Job 72326545REP1	Truss A2	Truss Type Truss	Qty 10	Ply 1	SD RALEIGH/ MCGINNIS BEH Job Reference (optional)
---------------------	-------------	---------------------	-----------	----------	--

Repair for broken bottom chord as shown.

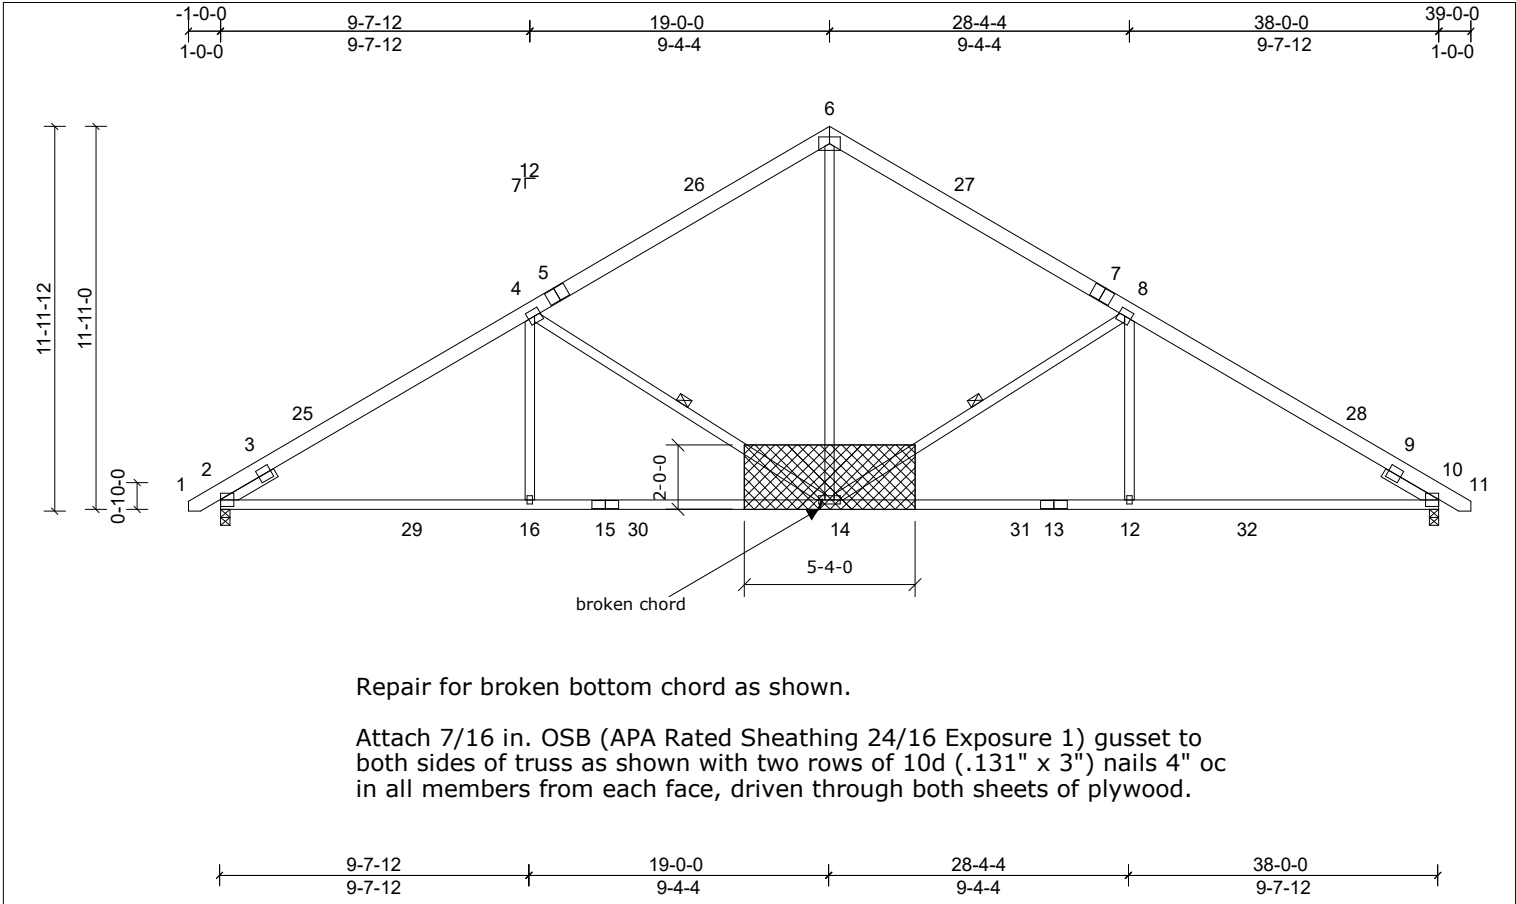
Attach 7/16 in. OSB (APA Rated Sheathing 24/16 Exposure 1) gusset to both sides of truss as shown with two rows of 10d (.131" x 3") nails 4" oc in all members from each face, driven through both sheets of plywood.
